Your Ref: 20/75551/FUL

Subject: 107 Light Oaks Road

Proposal: Erection of 4-bedroom detached house within existing side garden area

Highway comments:

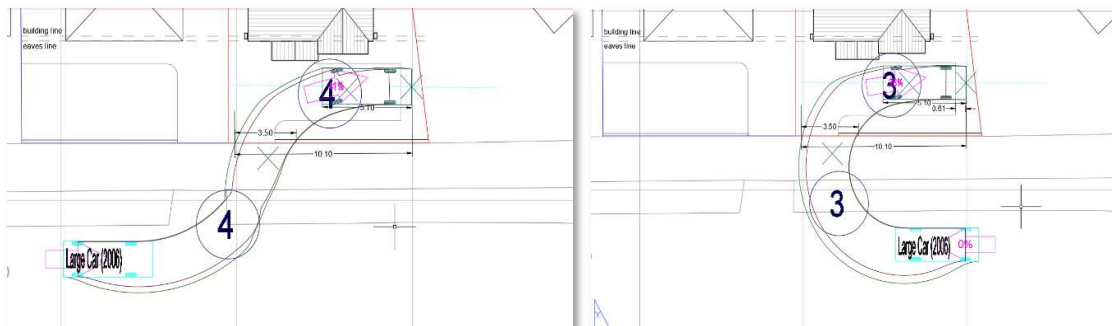
- ❖ The parking space associated to the proposed dwelling is not accessible due it is acute angle and close proximity to the access point. Please see swept path analysis below. I would recommend increasing the length of the parking space / forecourt area to have

a minimum length of 10m and provide an un-obstructed minimum access width of 3.5m to enable the swept path of a car reversing from the highway to the in-curtilage parking area. As there is insufficient room for a split swing gate, in this instance an internal sliding gate would be recommended.
